PROBLEM Solver™ BULLETIN

BULLETIN: 25931

Front Wheel Drive Lower Ball Joints

General Motors

K5263

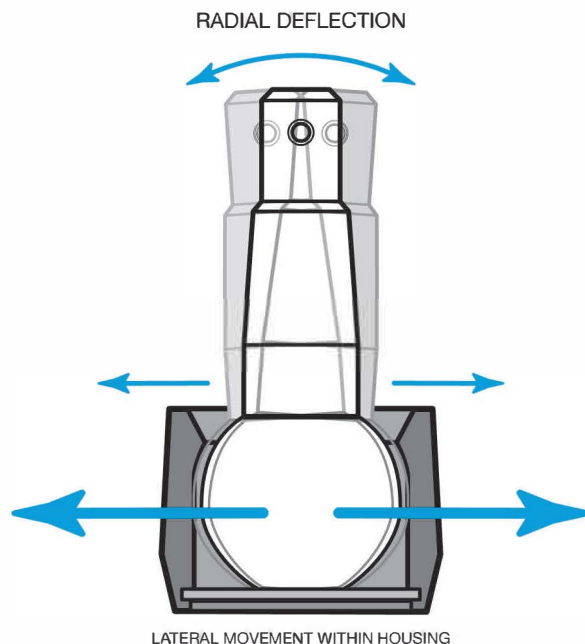
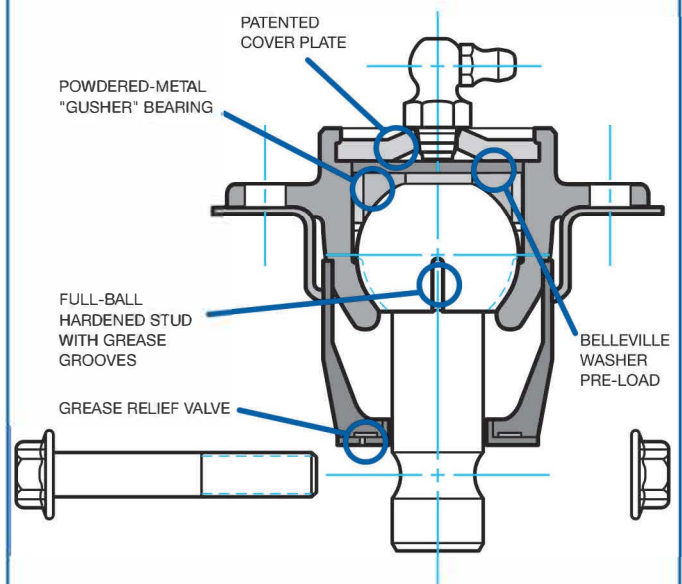
Premature ball joint wear

- Lateral deflection (side to side) loading causes excessive wear in ball joint.

MOOG® improved design K5263

- Utilizes patented MOOG cover plate design and NASCAR-proven split-bearing technology, which eliminates the excessive radial deflection often experienced with high lateral loads. The ball joint assembly maintains maximum ball-to-bearing contact for greater load carrying capability.
- Belleville washer pre-load provides lower torque and stud articulation with minimal axial clearance.
- Hardened powdered-metal bearings provide a smooth, durable wear surface that extends service life.
- A flange-style sealed boot equipped with a special grease-relief valve keeps contamination out and provides a serviceable sealed environment. (see drawing for Solution)
